Cecil + Associates responses
March 6, 2026
Only pages with comments have
been included in this document.

STEP BY STEP PARKING LOT REVISION

NOVEMBER 18, 2025
PERMIT #PRCCP20241731

2nd Submittal-1st Review of revised design.
PRCCP20241731
Dec 2025

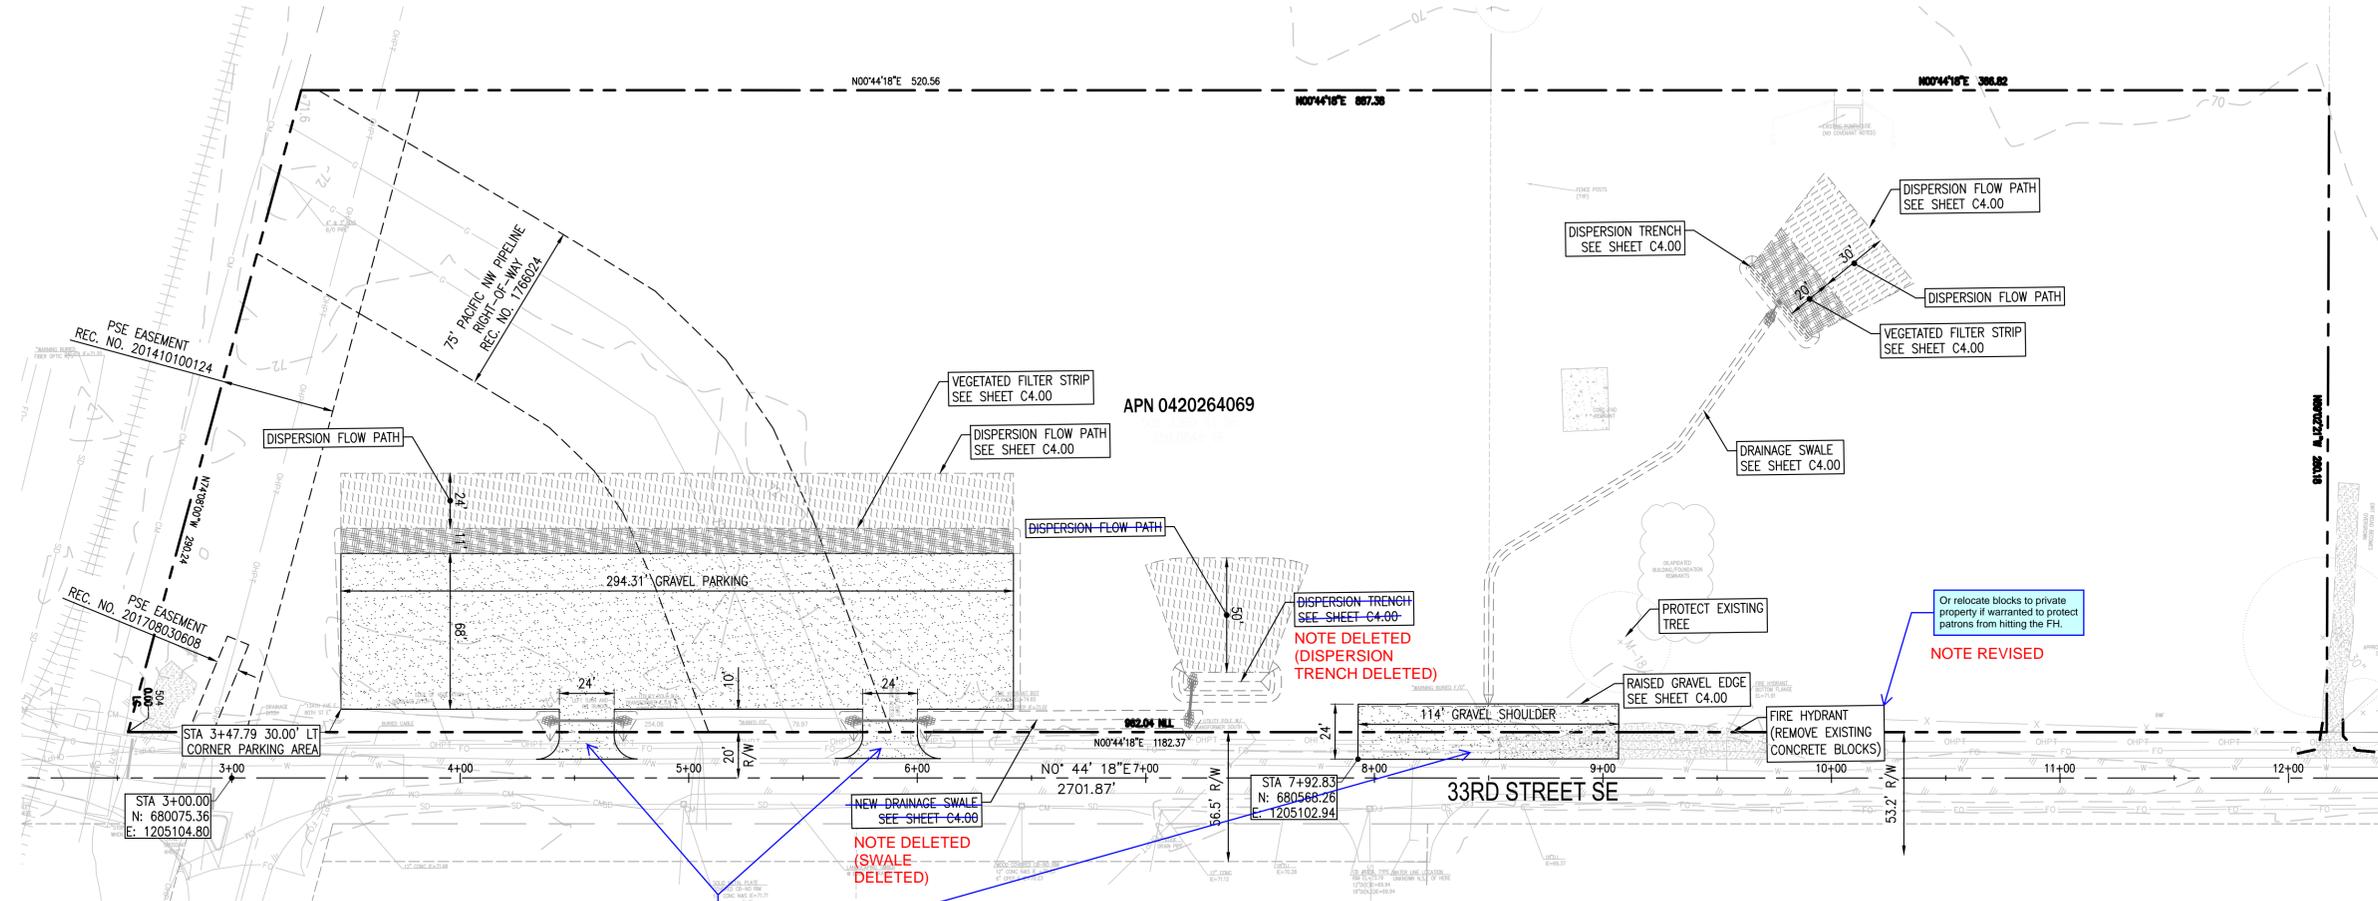
PERMEABLE BALLAST ADDED

Per 12/04/25 meeting use Permeable Ballast (or sim. permeable material).
 NEW HATCH PATTERN USED TO INDICATE PERMEABLE BALLAST.

NOTE DELETED (SWALE DELETED)

NOTE DELETED (DISPERSION TRENCH DELETED)

NOTE REVISED

NTE-66ft used in Storm Report. STORM REPORT UPDATED
